# STATE OF VERMONT AGENCY OF TRANSPORTATION

## PROPOSED IMPROVEMENT STATEWIDE RAILROAD CROSSINGS (SOUTHERN) COUNTY OF BENNINGTON TOWNS OF NORTH BENNINGTON MANCHESTER SHAFTSBURY TH 3, CL.2 (17-URBAN COLLECTOR) TH 1, CL.1 (16-URBAN MINOR ARTERIAL) TH 4, CL.2 (9-LOCAL ROAD) TH 9, CL.2 (7-RURAL MAJOR COLLECTOR) TH 7, CL.2 (9-LOCAL ROAD)

RECORD PLANS	
CONTRACTOR:	ECI RAIL CONSTRUCTORS, INC. - SO. BURLINGTON, VT
RESIDENT ENGINEER:	MARK HAUGHWOUT
CONSTRUCTION BEGAN:	JULY 16, 2007
CONSTRUCTION COMPLETE:	JANUARY 8, 2008
RECORD PLANS BY:	MARK HAUGHWOUT & N GARBACIK
I HEREBY CERTIFY THAT ALL THE CONSTRUCTION REQUIRED BY THIS SET OF DRAWINGS HAS BEEN ACCOMPLISHED AS INDICATED HEREIN.	
BY:	<i>Mark W. Haughwout</i> RESIDENT ENGINEER
DATE:	10/31/08
NOTE: Any further information concerning final quantities, amounts or other details relative to this project may be found at Central Files in the electronic archives.

DIRECTOR OF PROGRAM DEVELOPMENT	APPROVED: <i>Richard J. Filante</i> DATE: <i>01/08/08</i>
PROJECT MANAGER:	JENNIFER ROYER
PROJECT NAME:	STATEWIDE RAIL XING SOUTHERN REGION (RE-ADVERTISED)
SHEET 1 OF 21 SHEETS

**PLAN - BANK STREET**  
**AARDOT # 851-164P**

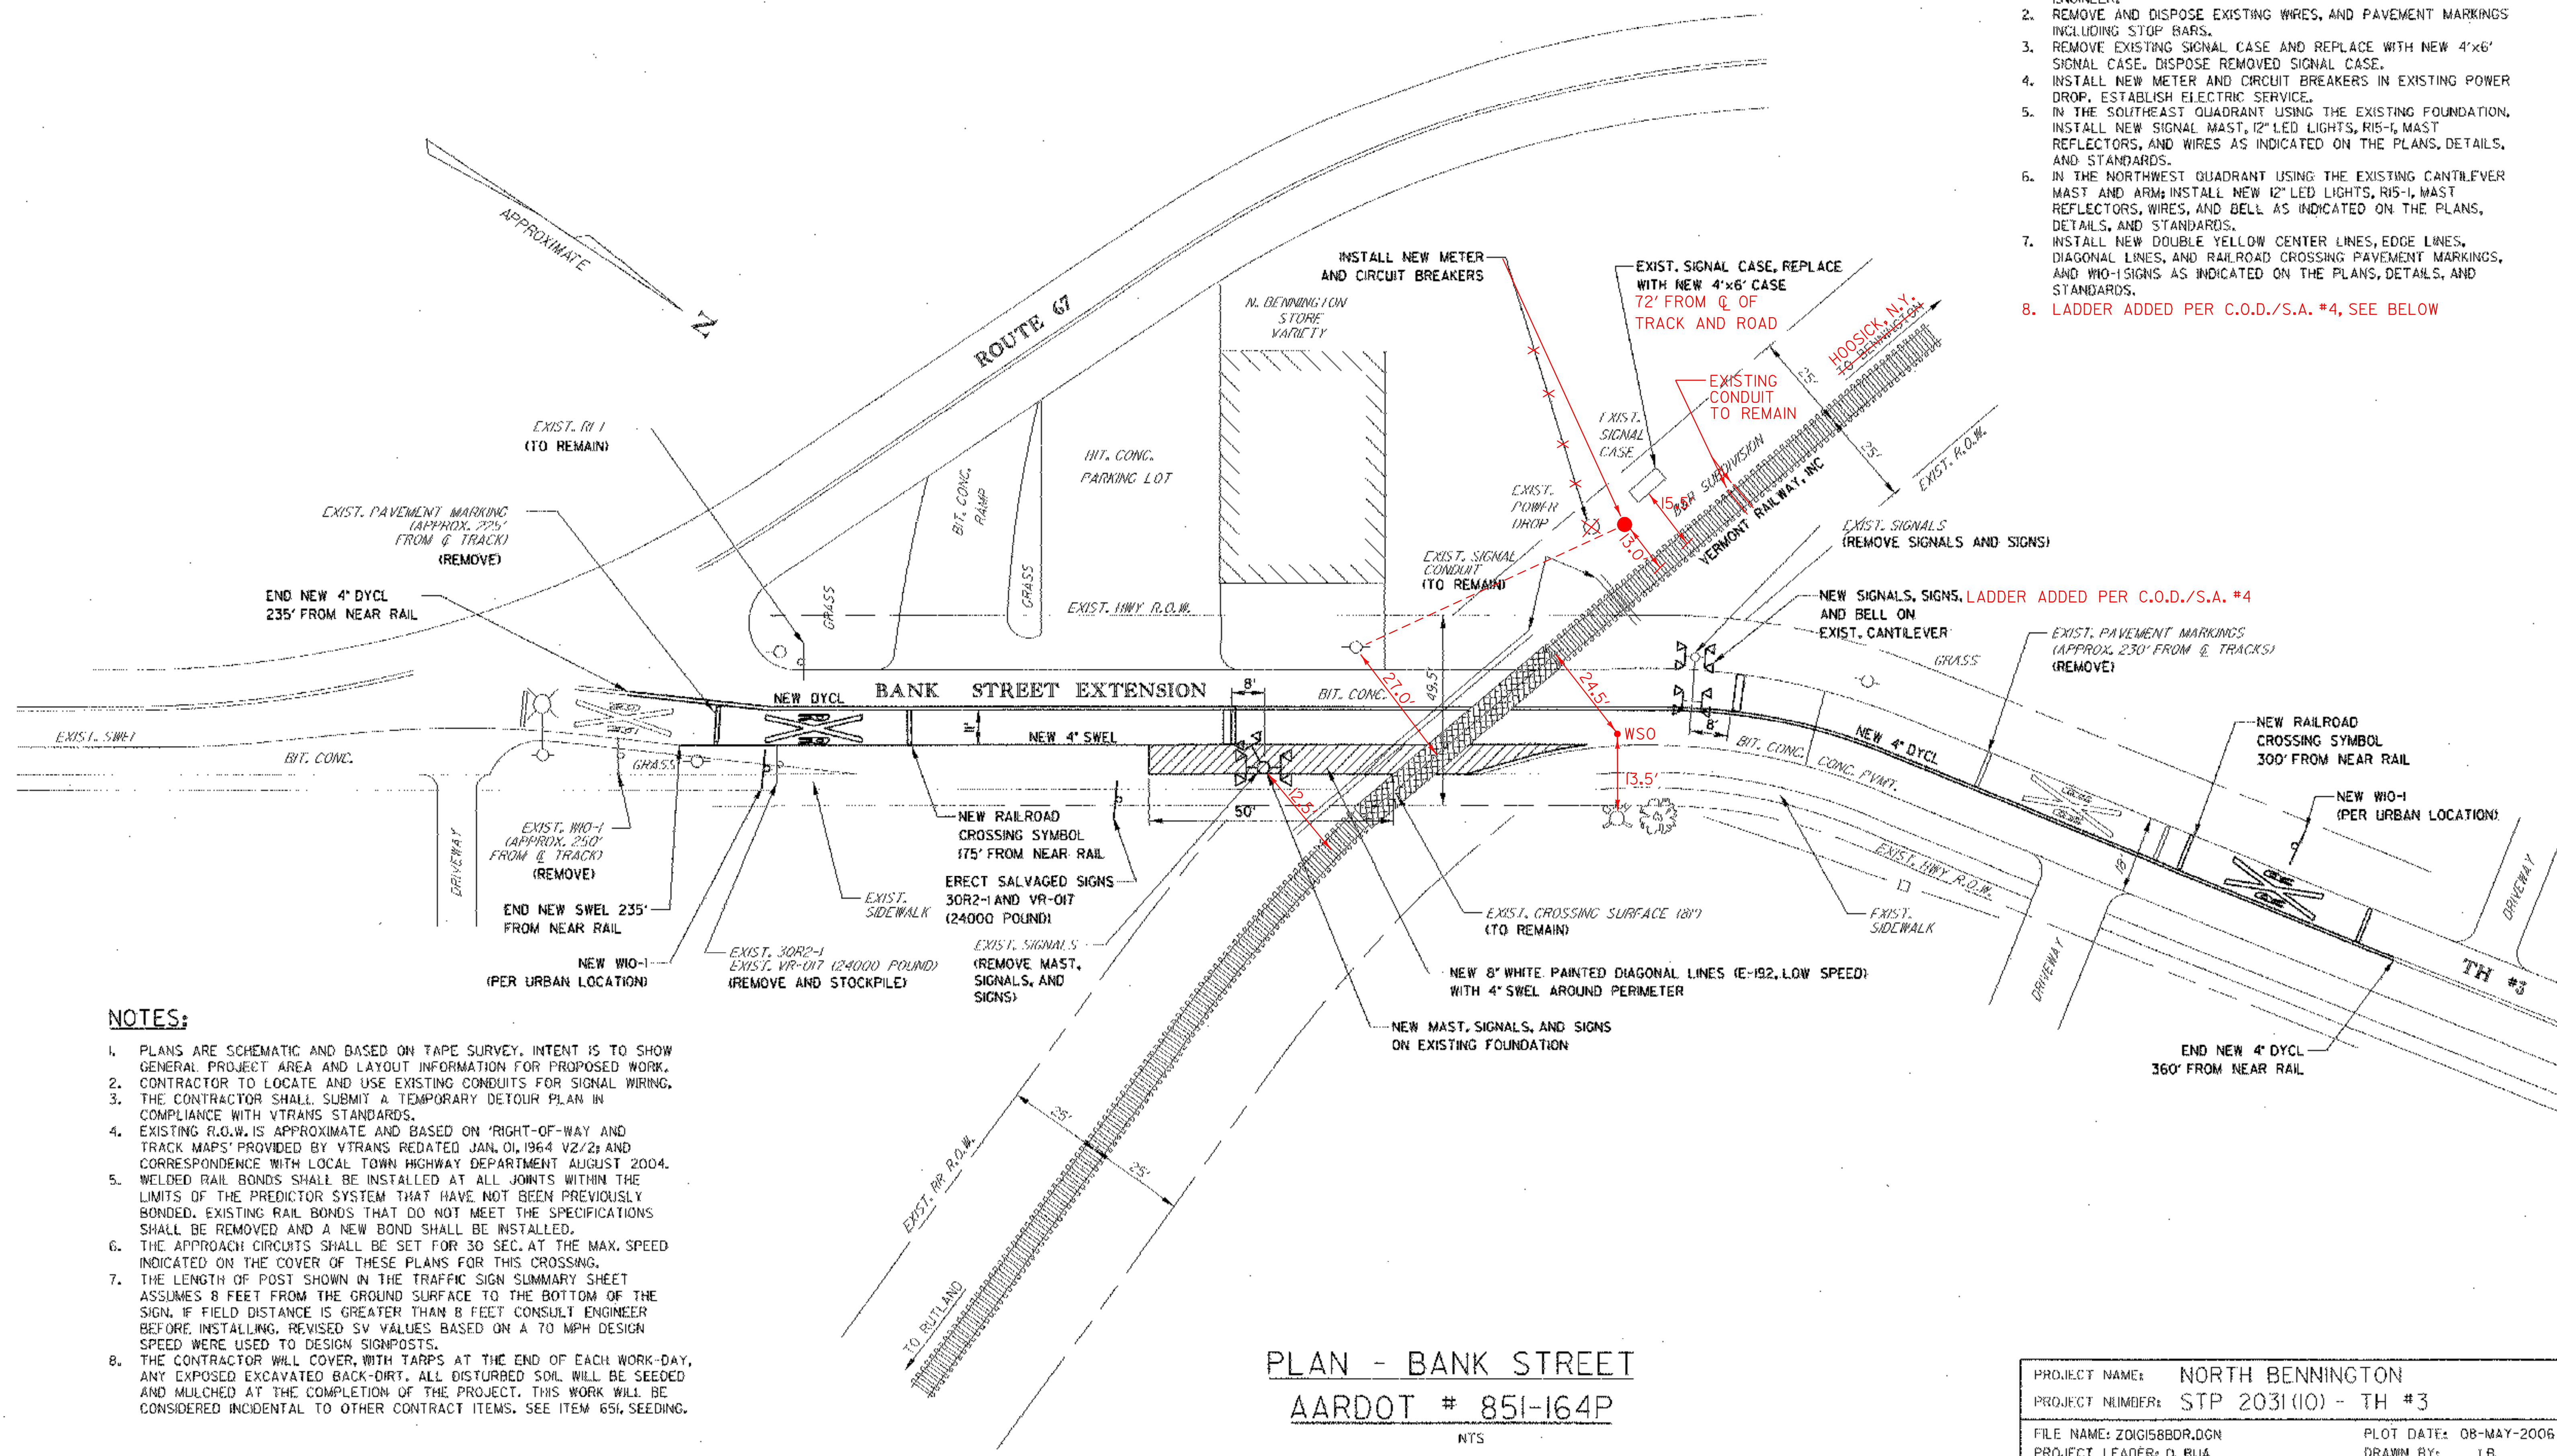
8. LADDER ADDED PER C.O.D./S.A. #4, SEE BELOW

**PLAN - MAIN STREET**  
**AARDOT # 851-165W**

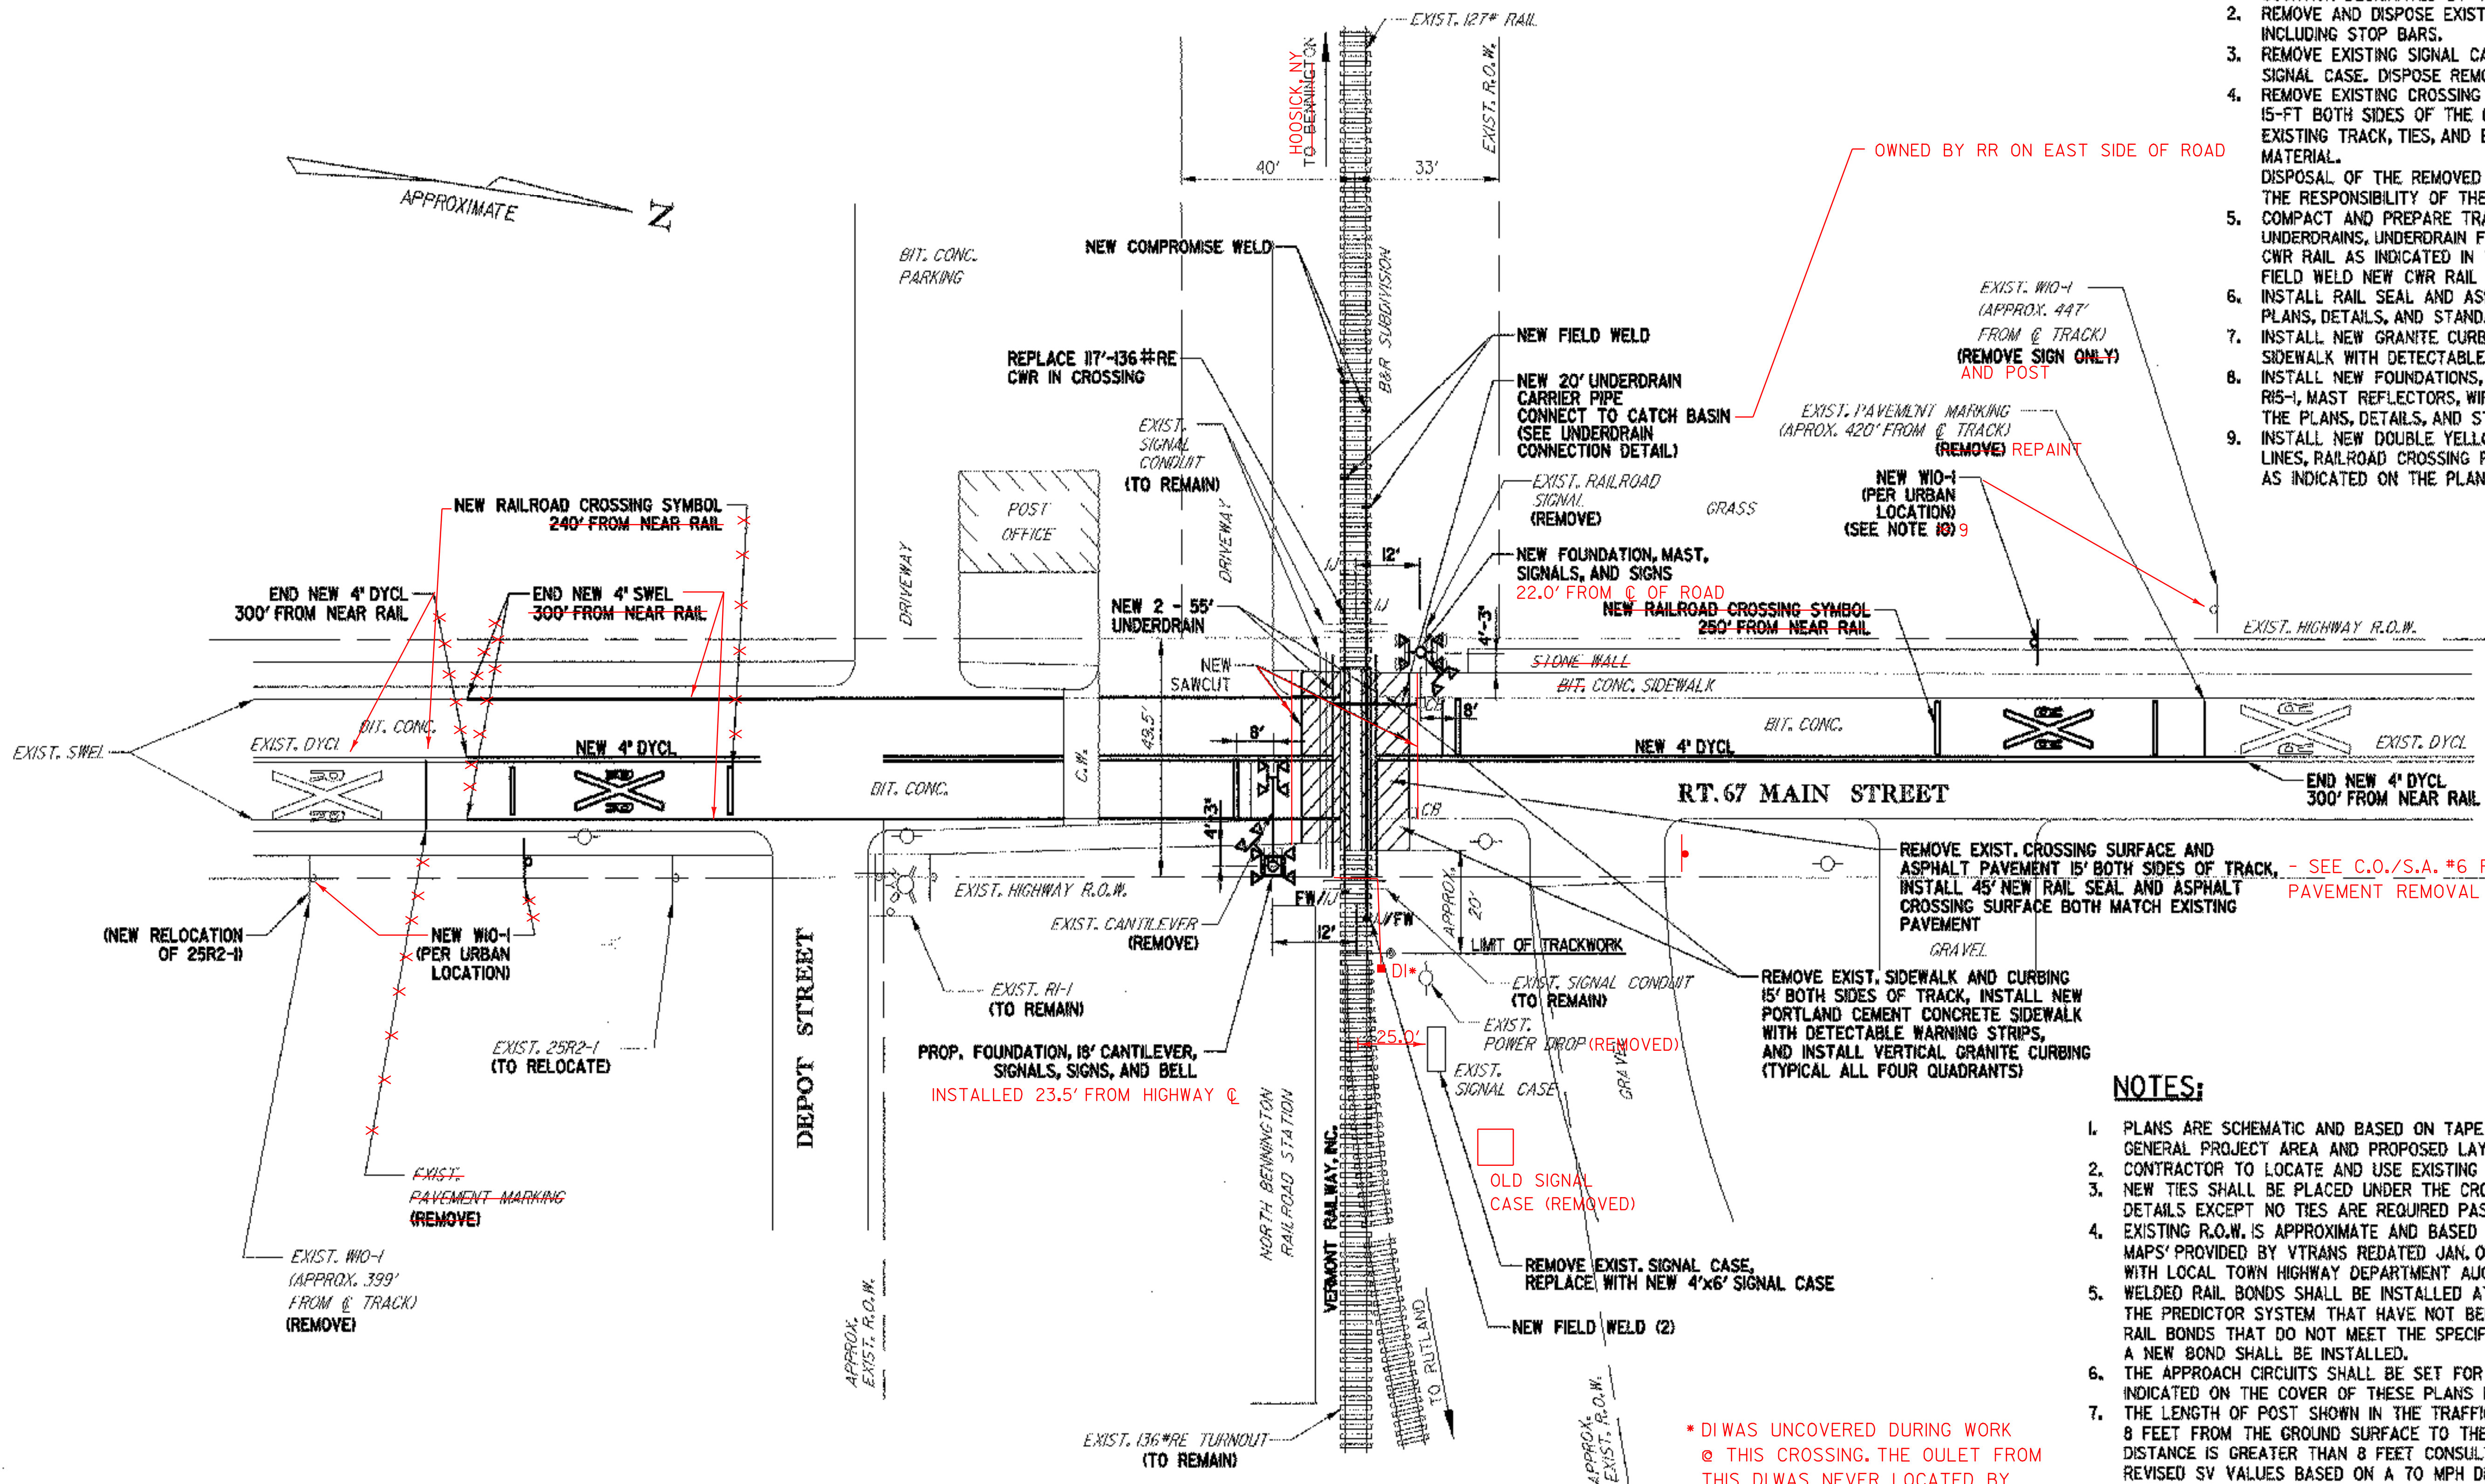
\* DI WAS UNCOVERED DURING WORK @ THIS CROSSING. THE OULET FROM THIS DI WAS NEVER LOCATED BY DIST. #1, CONST. OR RR PERSONEL. THE OLD UNDERDRAIN SYSTEM WAS REMOVED & FULLY PLUGGED. THE NEW UNDERDRAIN SYSTEM WAS INSTALLED TO OUTLET AT THIS DI.  
 DI IS 7.0' FROM RR C.  
 DI IS 38.0' FROM HIGHWAY C.
